From: "Certification Bureau / Bureau homologation (IC)"
<ic.certificationbureau-bureauhomologation.ic@canada.ca>
To: "Timothy R. Johnson" <tjohnson@acbcert.com>
Subject: RE: Label Permission Request

FCC/IC Label & Location for Intel Models using form factor D2

SILK PRINTING SPECIFICATION

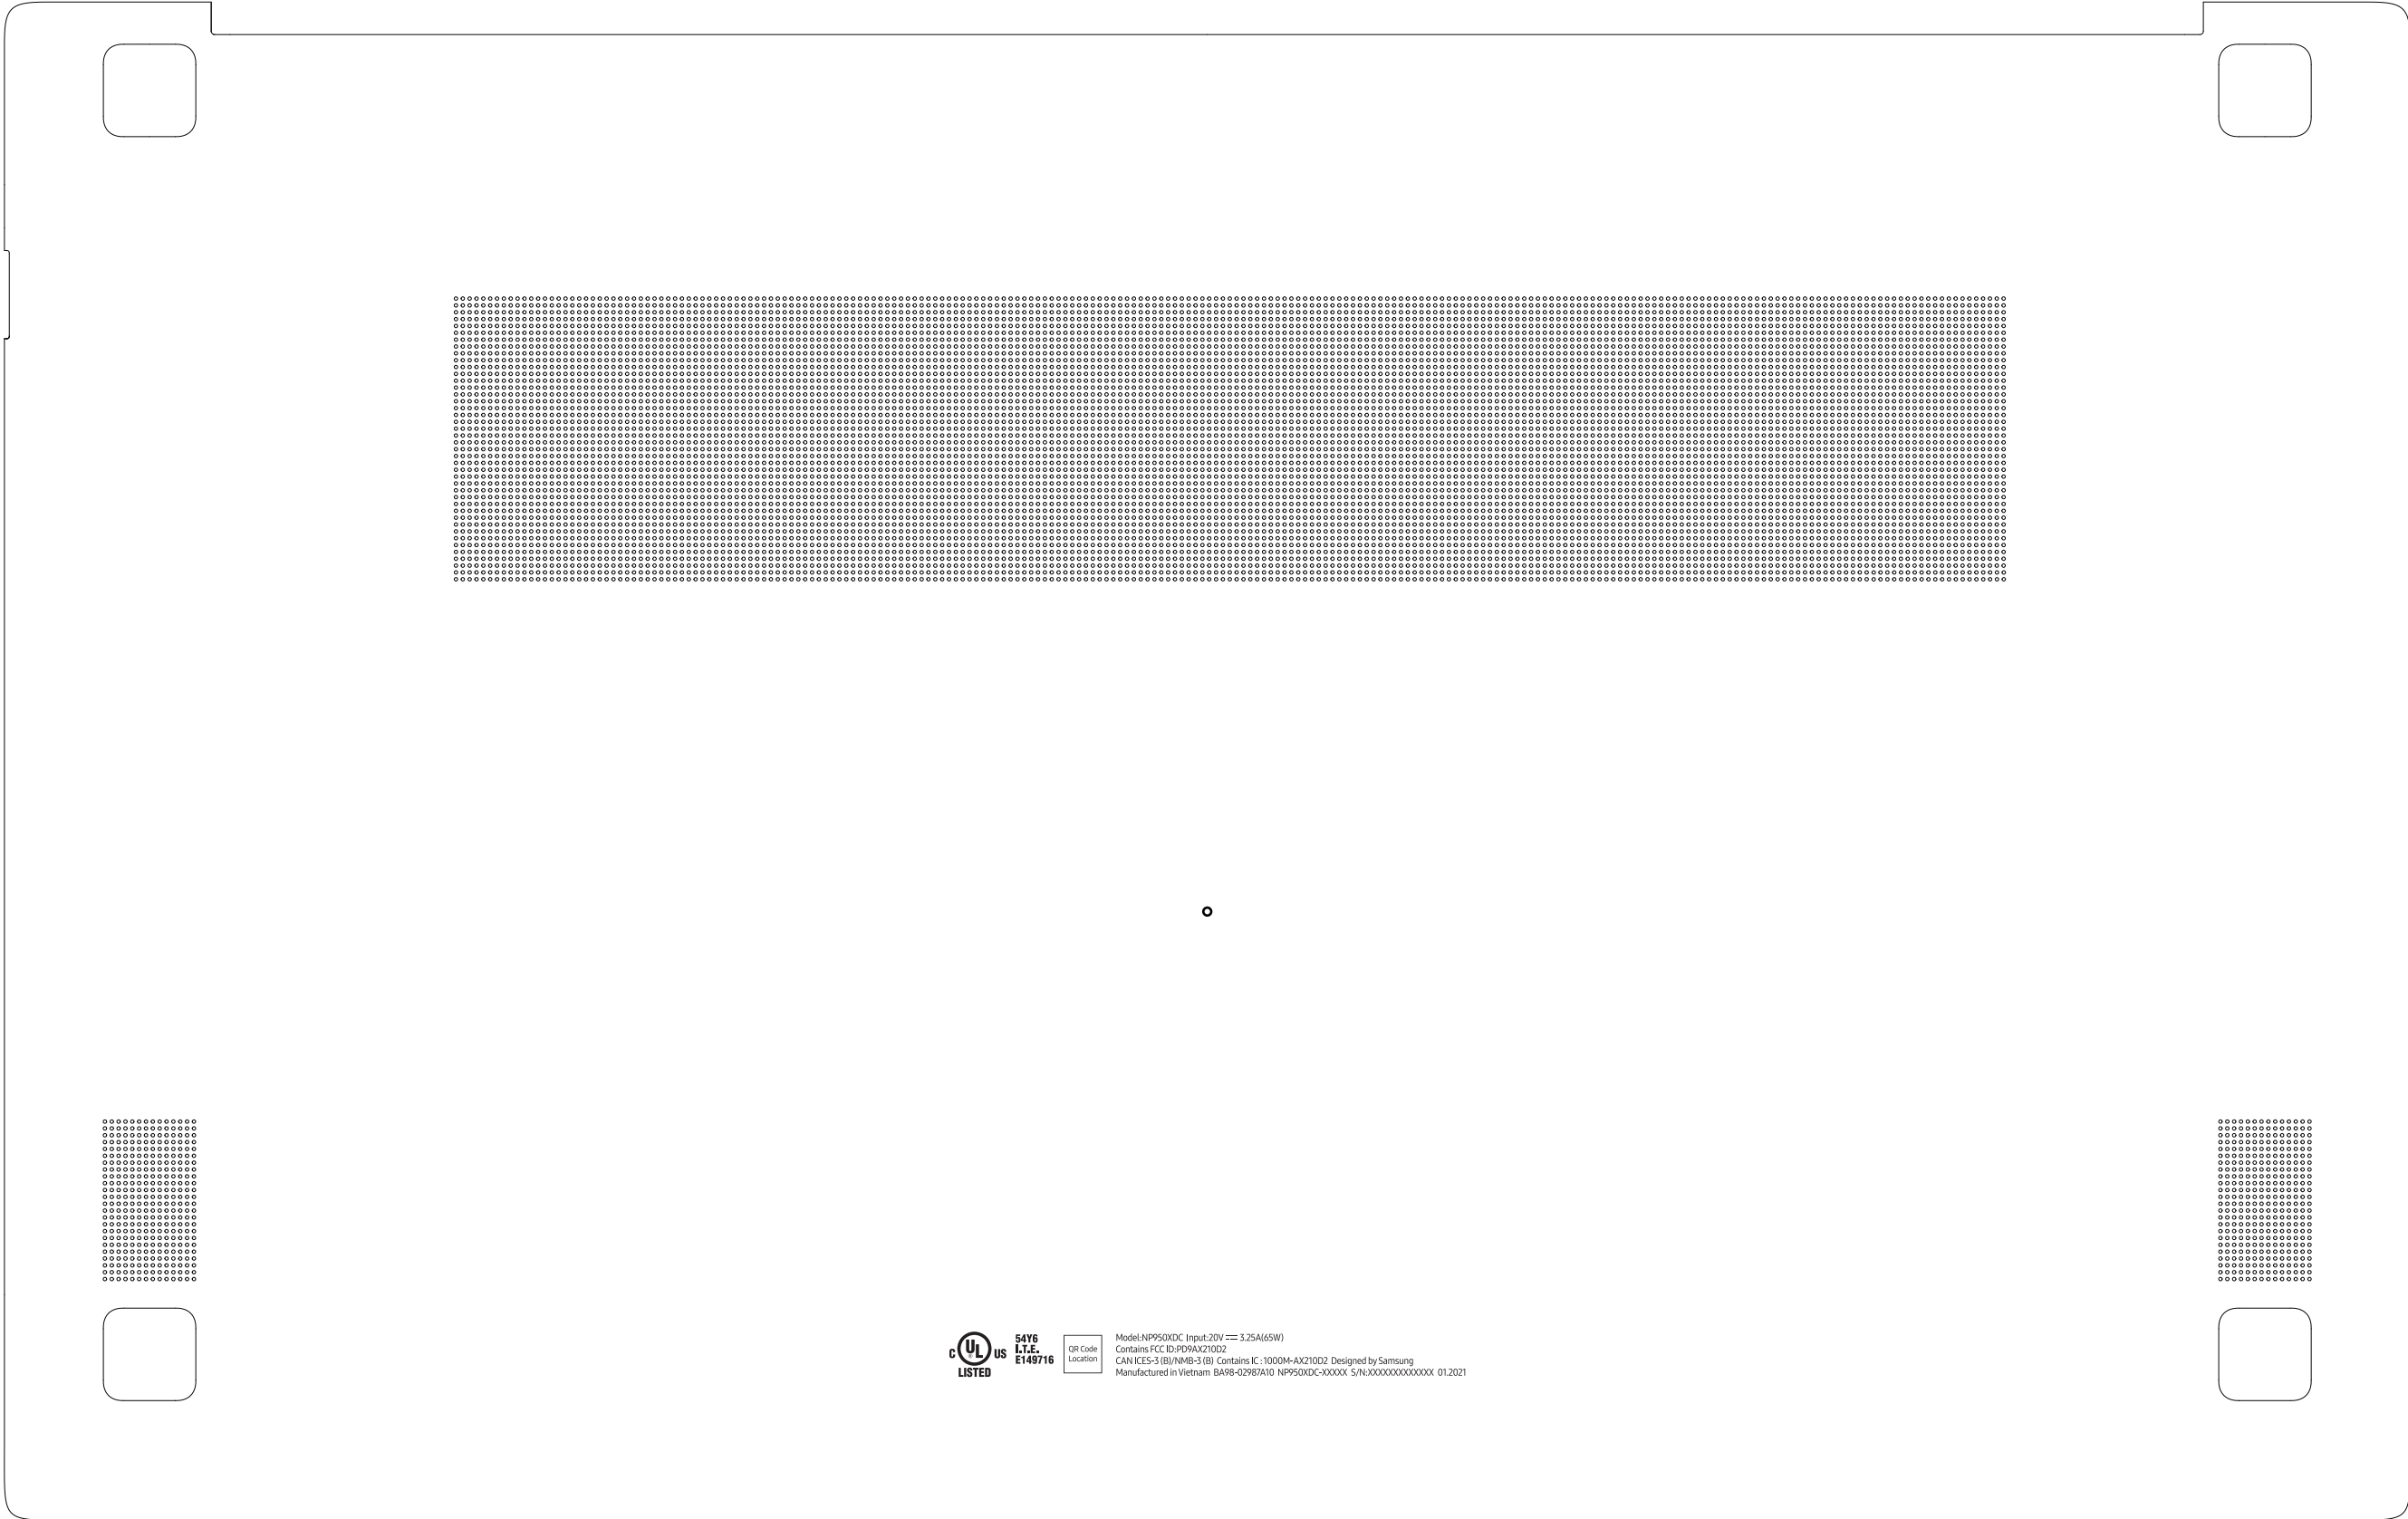
The device is considered to be too small for the label since it is impracticable to label with a font size that is four-points or larger. The FCC ID is instead placed in the users manual as allowed by KDB 784748 and as allowed by ISED previously on this form factor.

Intel submitted and application to ACB in December. For the labeling exhibit they submitted the label with an explanation that the form factor has been accepted in the past by ISED. ISED asked for us to provide Intels previous correspondence in order to proceed as well as something denoting appropriate sizes and the application has been in pass back since December.

Our contact at Intel is fairly certain ISED has granted them permission in the past on this form factor, but has not had the time to investigate and provide the past proof and is currently "buried" in other priorities. Therefore on their behalf we are submitting the attached and requesting permission for the labeling to be placed into the manual based on the information provided.

They use the basic form factor for many devices and have several upcoming approvals based on the same form factor (known as D2 to Intel) as well. If possible we would like to obtain permission for Intel to place the labeling in the manual for all certifications that they use this particular form factor.

Could ISED please review the attached and provide feedback as appropriate?

Label exemption would be acceptable for this device. Please place the label information in accompanying literature.
